Metropolitan Historic Zoning Commission
Sunnyside in Sevier Park
3000 Granny White Pike
Nashville, Tennessee 37204
Telephone: (615) 862-7970
Fax: (615) 862-7974

STAFF RECOMMENDATION
1513 Woodland Street
July 18, 2017

Application: New construction—detached accessory dwelling unit
District: Lockeland Springs-East End Neighborhood Conservation Zoning Overlay
Council District: 06
Map and Parcel Number: 08309039900
Applicant: Corley Roberts
Project Lead: Melissa Baldock, melissa.baldock@nashville.gov

Proposal 4

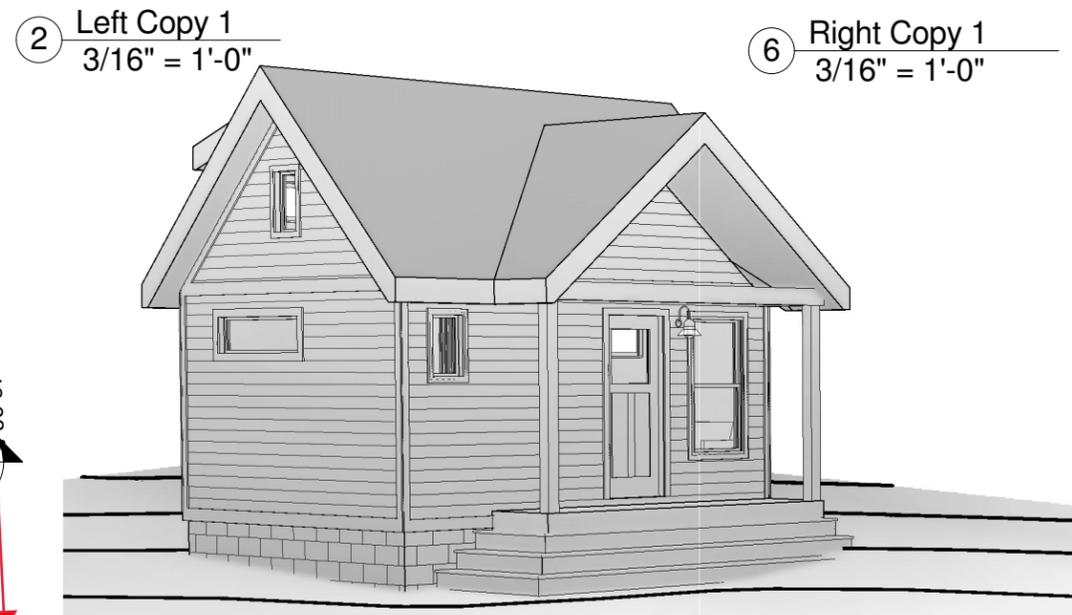
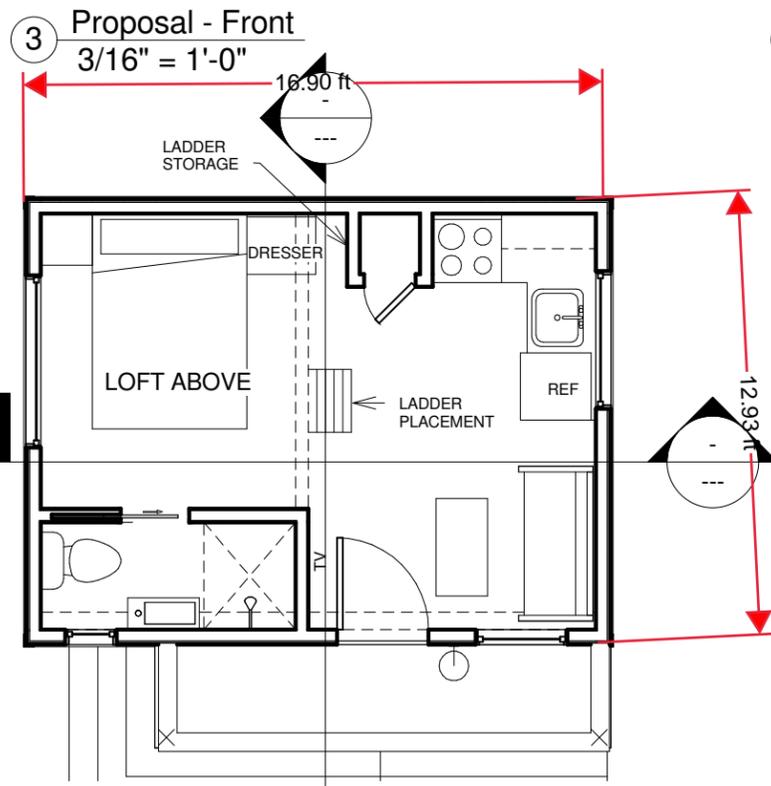
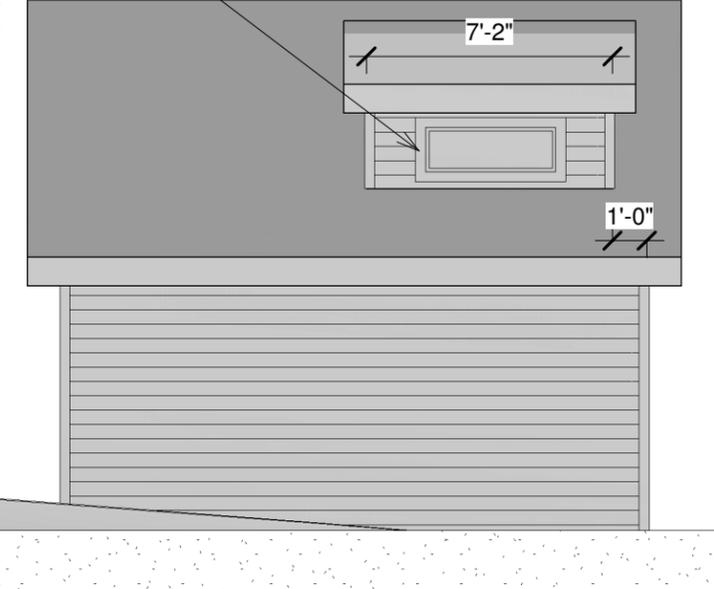
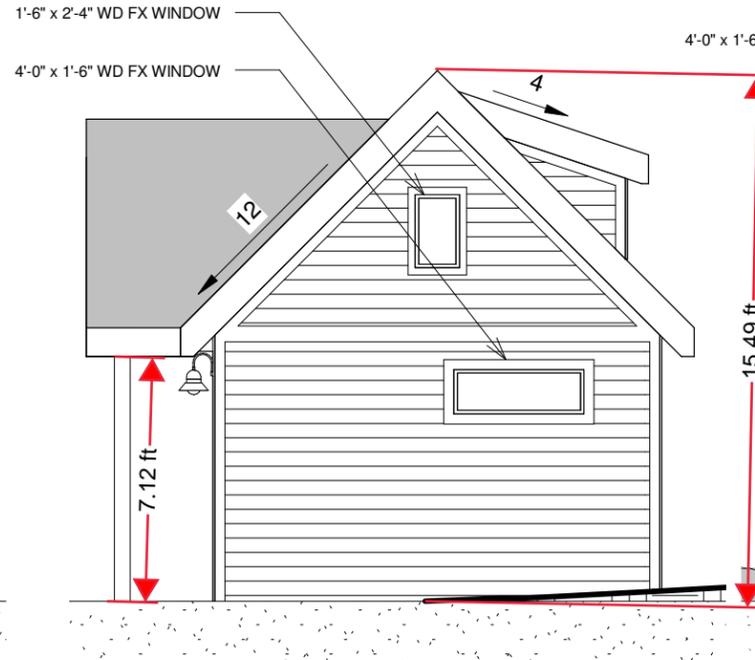
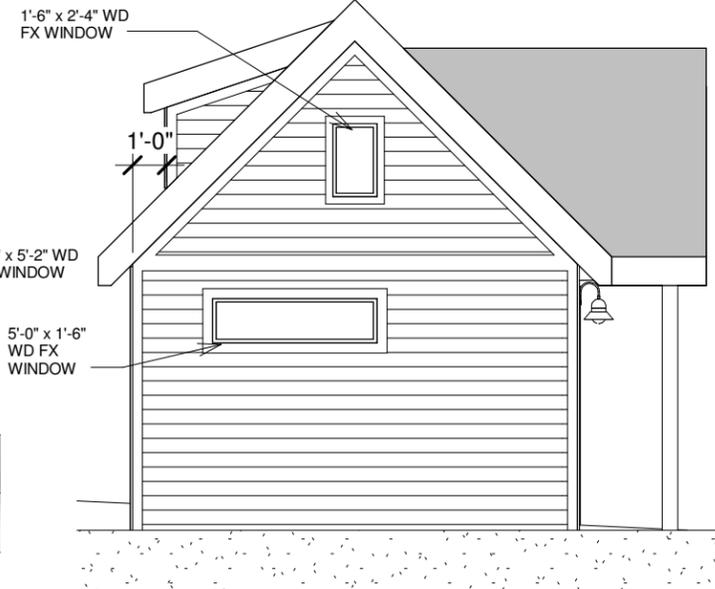
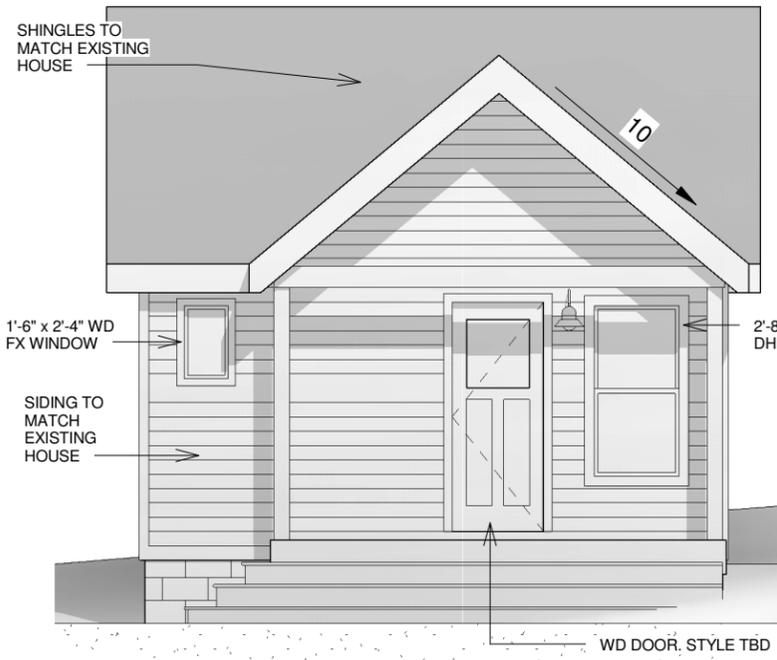
**The DADU ordinance and the design guidelines require dormers to be setback two feet (2’) from the exterior wall. The applicant is proposing a dormer which is inset just one foot (1’). Staff finds the dormer’s inset to be appropriate, in this instance, because the dormer is so small, that requiring it to be setback further than one foot (1’) would render it too small to be usable. The dormer is just seven feet, six inches (7’6”) wide, and is set off of the roof ridge. Staff finds that its scale is appropriate to the small size of the proposed DADU.

Proposed Element	Proposed Form	Typical of district?
Primary form	Gable	Yes
Primary roof slope	12/12	Yes
Porch form	Gable	Yes
Porch slope	10/12	Yes
Dormer form	Shed	Yes
Dormer slope	4/12	Yes

Proposed	Color/Texture	Approved Previously or Typical of Neighborhood
Foundation	Concrete slab	Natural color	Yes
Cladding	Cement-fiber	Match existing house or max of 5"	Yes
Roofing	Architectural shingles	Unknown	Unknown – requires approval of color
Trim	Cement fiber	smooth	Yes
Porch floor and steps	Not indicated	Unknown	Unknown – requires approval
Porch Posts	Wood	Typical	Yes
Windows	Unknown	Unknown	Unknown- requires approval
Pedestrian Door	Unknown	Unknown	Unknown- requires approval

Design Standards: The accessory structure has a simple, utilitarian design that is appropriate for outbuildings. Its roof form, detailing, and form do not contrast greatly

with the primary structure. The fenestration is of a more modern layout, but it is appropriate for an outbuilding. The outbuilding will be located at the rear of the house in a minimally-visible location. Staff finds that the DADU's design meets Sections II.B.8 of the design guidelines and Section 17.16.030.G.8 of the ordinance.

1. Staff approve the final details, dimensions and materials of windows and doors prior to purchase and installation;
2. Staff approve the porch steps and floor material; and
3. Staff approve the roof shingle color.
